Before the  
Federal Communications Commission  
Washington, D.C. 20554

ARINC Inc. )

Application for Blanket Authority to Operate )  
Aboard Aircraft Up To 1000 Technically- )  
Identical Transmit and Receive Mobile Earth )  
Stations in the 11.7-12.2 and 14.0-14.5 GHz )  
Frequency Bands )

**SUPPLEMENTAL COMMENTS OF THE BOEING COMPANY**

**ARINC Off-Axis EIRP Probability Envelop**

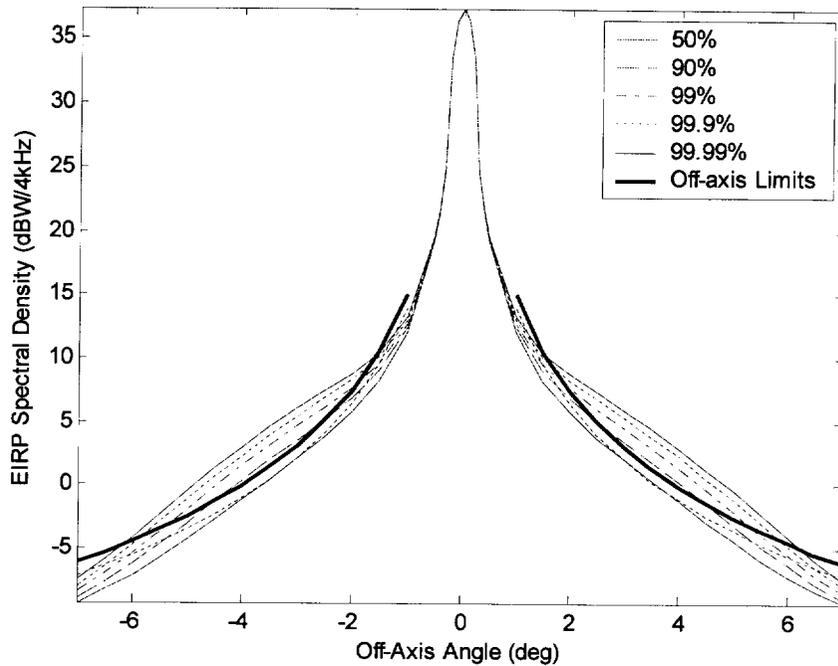
The results of all 100,000 trials were then used to compute off-axis EIRP probability envelopes for the proposed ARINC system, which is compared to the off-axis EIRP levels set forth in the Commission's rules and the work performed in WP 4A. As indicated in the following chart, ARINC's 99.99% EIRP envelope *exceeds* the off-axis levels set forth in the Rules by 3.1 dB. This compares to the WP 4A studies where the 99.99% EIRP envelope was found to be 1 dB *below* these levels for a properly designed AMSS system. The proposed ARINC system would exceed these levels between 1.5 degrees and 6.2 degrees off-axis and at certain points the probability of exceeding the levels reaches 10%.<sup>37</sup>

<sup>37</sup> See *id.* at 8-9. ARINC's proposed operations at 103° W.L. would cause the area of exceedance to include at least four adjacent Ku-Band satellites: Galaxy 4R at 99° W.L., AMC 4 4R at 101° W.L. (where Boeing has operations), AMC 2 4R at 105° W.L., and Anik F1 at 107.1° W.L.

As reflected in this analysis, the proposed AMSS system poses a significant risk to operations of adjacent FSS satellites. Factors that ARINC does not adequately account for include:

- Pointing error,
- EIRP variations due to closed loop power control and reverse calculation error,
- Contributions of the forward uplink signal to the aggregate emissions received at the geostationary arc, and
- The 99.99% error envelope considered in previous AMSS studies.

ARINC should be required to account for these and other factors set forth in Recommendation ITU-R M.1643, including positive control of AES transmissions.

**Figure 2. 99% Off-axis EIRP Considering Only Contention Protocol Access**

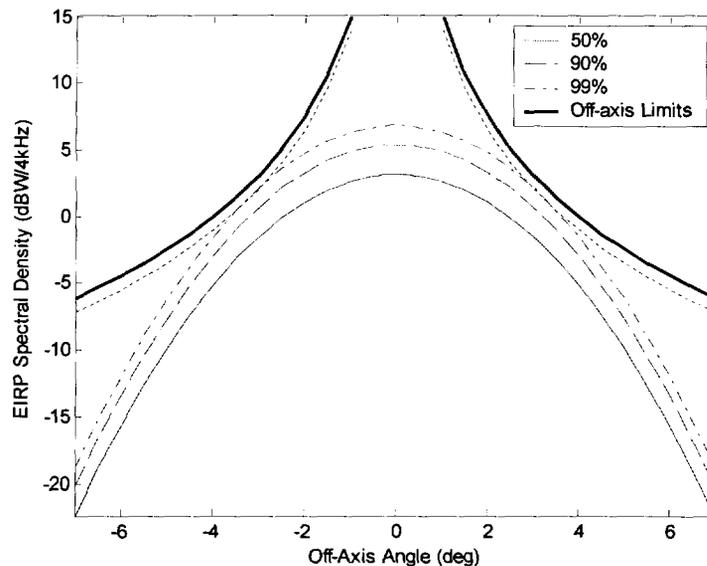
The simulation assesses the minimum number of simultaneous accesses that will fully load a sub-band in order to determine the maximum off-axis EIRP.<sup>13</sup> For this simulation, the minimum number of simultaneous accesses that will fully load the system is assumed to be seven, which occurs when a single 13.824 MHz return link sub-band is occupied by 128 kbps AESs. The resulting individual input power density is -32.59 dBW/4kHz.<sup>14</sup> Assuming the maximum duty cycle remains the same at 12.25%, seven simultaneous accesses will occur 1% of the time for a pool of 25 logged-in AESs.

In order to test these assumptions, Boeing performed a simulation to duplicate the off-axis EIRP performance of the proposed ARINC system as described in the ARINC Response. Figure 2, below, shows the results of this simulation. The 99% off-axis EIRP envelope remains 1 dB below the off-axis levels contained in the FCC's rules when all sources of off-axis EIRP variation except contention protocol access are set to zero, as assumed by ARINC. (Boeing disputes that it is appropriate to assume away such sources of off-axis EIRP variation.) This validates that Boeing's assumptions regarding duty cycles and numbers of logged-in AESs are reasonable in the absence of data provided by ARINC.

**Figure 3. Forward Uplink Off-axis EIRP**

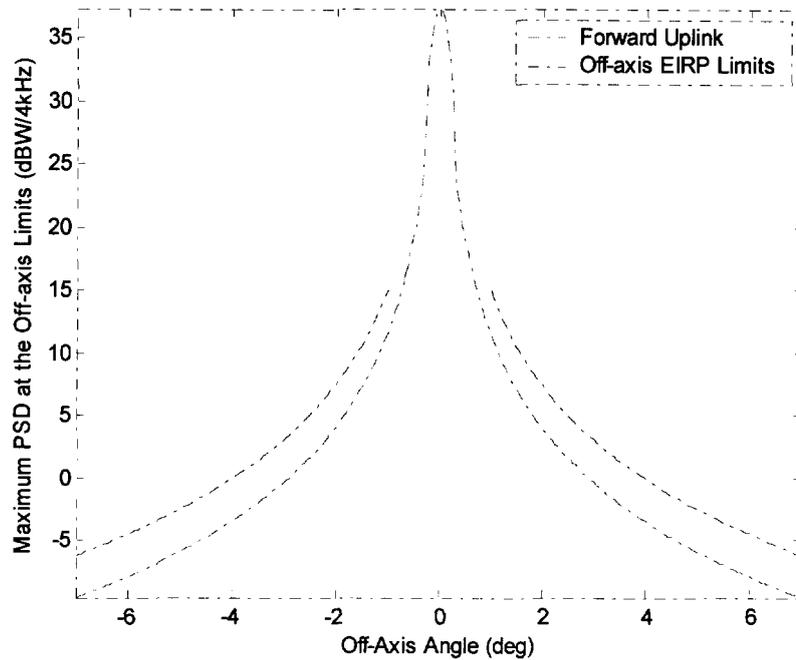
ARINC employs a Paired Carrier Multiple Access (“PCMA”) scheme whereby the forward and return links operate co-frequency in the same transponder.<sup>26</sup> Boeing has commented that the off-axis EIRP of the forward link should be accounted for in the aggregate off-axis EIRP.<sup>27</sup> ARINC has indicated that it intends to use a 4.5 m antenna that is compliant with Section 25.209 of the Rules that is authorized for an input power of -17.4 dBW/4kHz.<sup>28</sup> For the purpose of this simulation the forward link antenna is treated as having a peak gain of 54.7 dBi that rolls off parabolically to +/- 0.5 degrees off-axis. Beyond +/- 0.5 degrees the antenna is treated as rolling off in accordance with Section 25.209 (*i.e.*,  $29 - 25 \log(\theta)$  dBi), as is shown in Figure 3.

**Figure 4. ARINC Off-Axis EIRP Probability Envelopes**

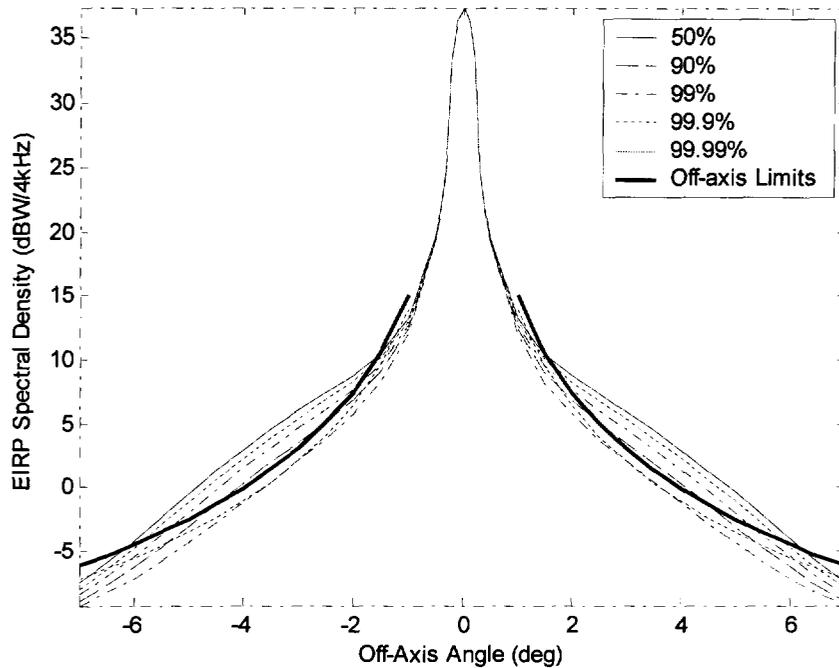
Figure 4 shows the results for the proposed ARINC system of 100,000 trials considering all of the contributions to aggregate off-axis EIRP described above, including the forward uplink. The ARINC 99.99% EIRP envelope *exceeds* the off-axis levels set forth in the Rules by 3.1 dB. This compares to the WP 4A studies where the 99.99% EIRP envelope was found to be 1 dB *below* these levels. The proposed ARINC system exceeds the levels between 1.5 degrees and 6.2 degrees off-axis and at certain points in this region the probability of exceeding the levels reaches 10%.<sup>29</sup> Considering ARINC's proposed operations at 103° W.L., the area of exceedance includes at least four adjacent Ku-Band satellites: Galaxy 4R at 99° W.L., AMC 4 4R at 101° W.L. (where Boeing has operations), AMC 2 4R at 105° W.L., and Anik F1 at 107.1° W.L. The area of exceedance falls only a few tenths of a degree short of the Intelsat Americas 5 at 97° W.L.

<sup>29</sup> Even if the forward uplink could be totally neglected, which is unlikely, the proposed ARINC system would still exceed the off-axis levels by up to 2.1 dB over a range of 2.2 degrees to 5.2 degrees off-axis.

As a result, the proposed ARINC system will exceed the off-axis levels by up to 3.1 dB between 1.5 degrees and 6.2 degrees off-axis as much as 10% of the time.
